Accessibility Survey

City of Downey Birchdale Avenue - 5th Street To End

Prepared By

Disability Access Consultants

Change in Level South of 6th Street @ 33.941742259030, -118.124356269836

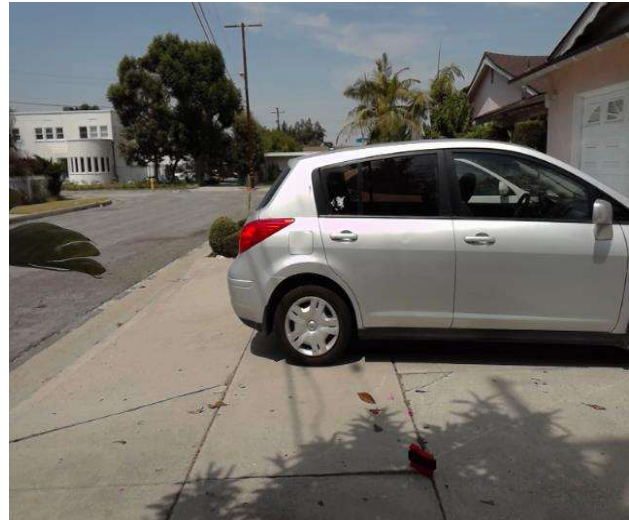
There is a change in elevation greater than recommended value.

On-Site Finding 0.50 inches

Ensure that the change in elevation is within the recommended value.

Recommendation Up to 0.25 inches

Change In Level South Of Donovan Street @ 33.922147330354, -118.138852268457

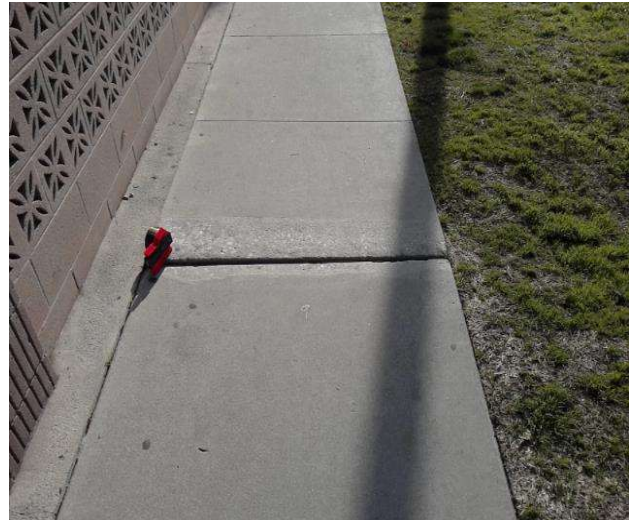
There is a change in elevation greater than recommended value.

On-Site Finding 0.62 inches

Ensure that the change in elevation is within the recommended value.

Change In Level South Of Melva Street @ 33.924615582591, -118.136997520924

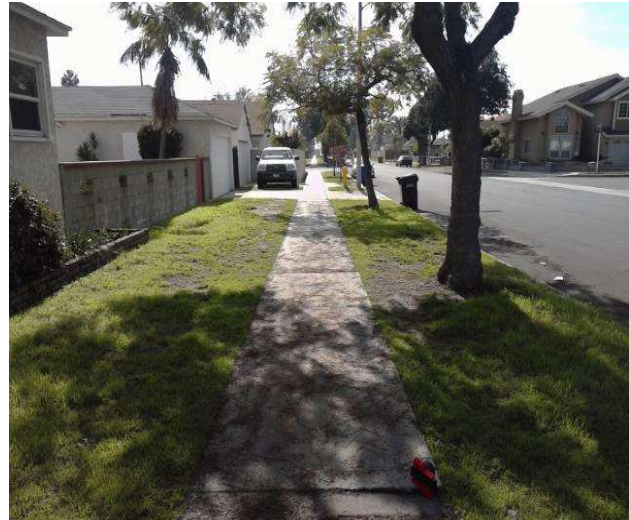
There is a change in elevation greater than recommended value.

On-Site Finding 0.75 inches

Ensure that the change in elevation is within the recommended value.

Change In Level North Of Boyson Street @ 33.924693479379, -118.137162476778

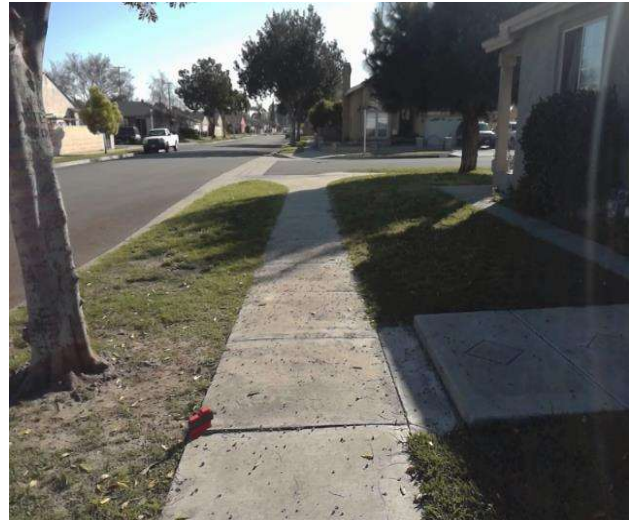
There is a change in elevation greater than recommended value.

On-Site Finding 0.62 inches

Ensure that the change in elevation is within the recommended value.

Change In Level North Of Boyson Street @ 33.924914928428, -118.136984109879

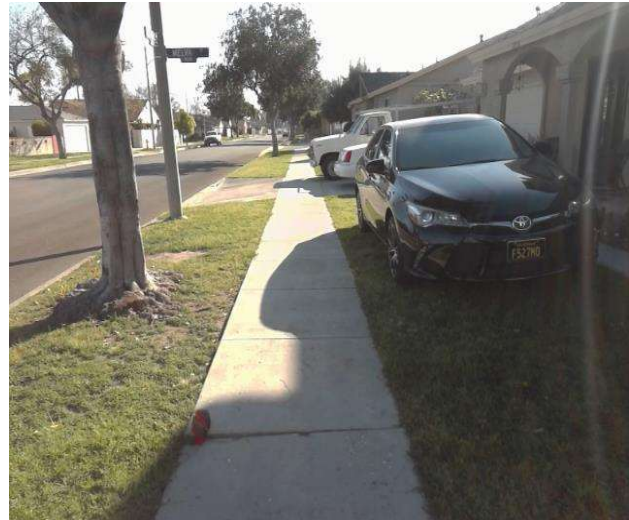
There is a change in elevation greater than recommended value.

On-Site Finding 0.87 inches

Ensure that the change in elevation is within the recommended value.

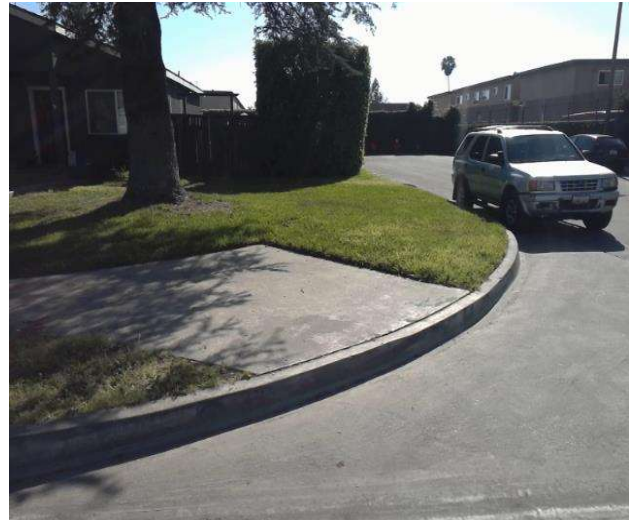
There is a curb on the designated path of travel.

On-Site Finding Not Compliant

Provide a compliant curb ramp.

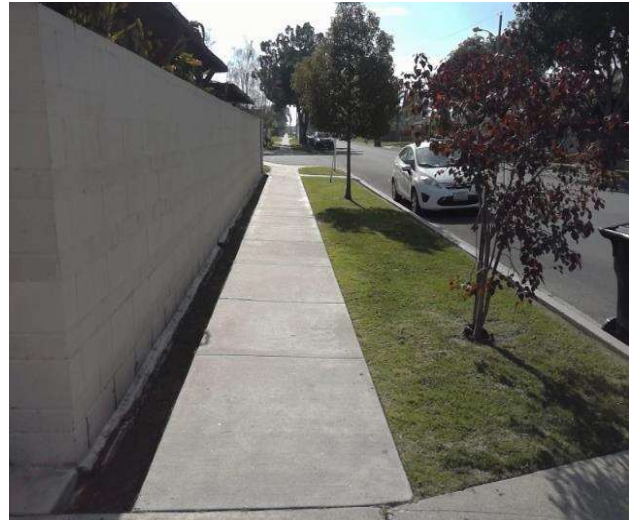
Sidewalk cross slope is not compliant.

On-Site Finding 4.50 percent for 77.00 feet

Repave the sidewalk surface with the recommended cross slope.

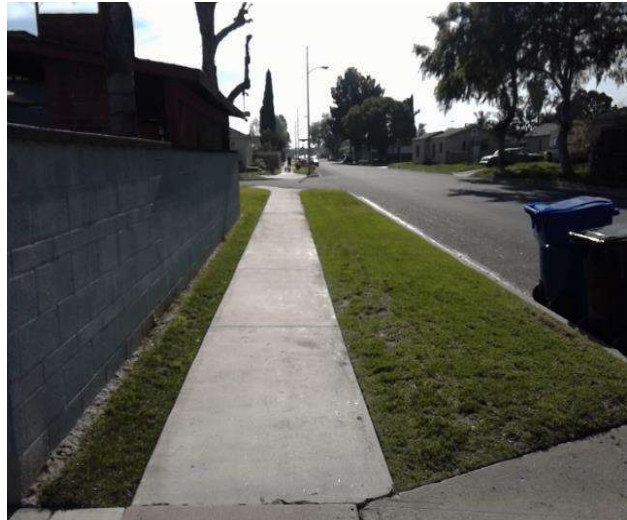
Sidewalk cross slope is not compliant.

On-Site Finding 3.70 percent for 71.00 feet

Repave the sidewalk surface with the recommended cross slope.

Change in Level South of Cherokee Drive @ 33.944801820986, -118.123256564140

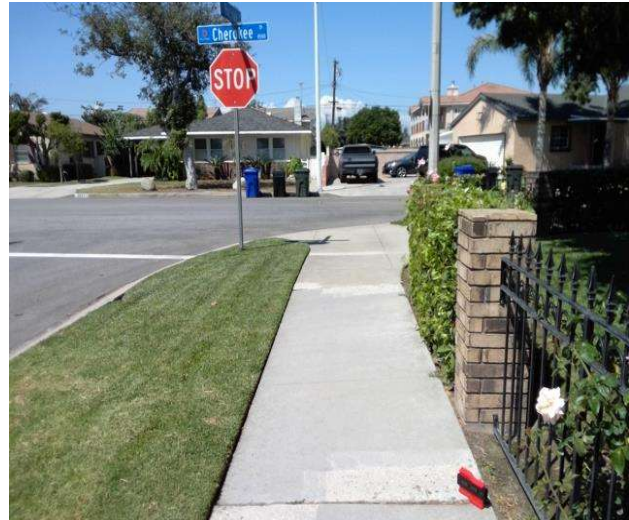
There is a change in elevation greater than recommended value.

On-Site Finding 0.62 inches

Ensure that the change in elevation is within the recommended value.

Change in Level North of Muller Street @ 33.943521268617, -118.124424666166

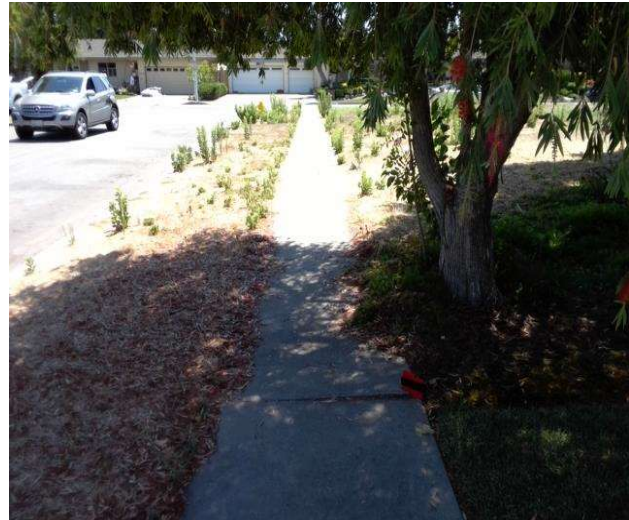
There is a change in elevation greater than recommended value.

On-Site Finding 0.87 inches

Ensure that the change in elevation is within the recommended value.

Change in Level South of Raviller Drive @ 33.953964273036, -118.115091919899

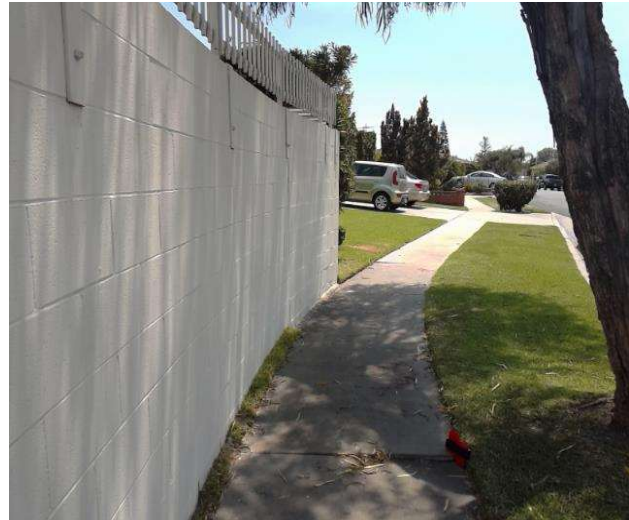
There is a change in elevation greater than recommended value.

On-Site Finding 1.25 inches

Ensure that the change in elevation is within the recommended value.
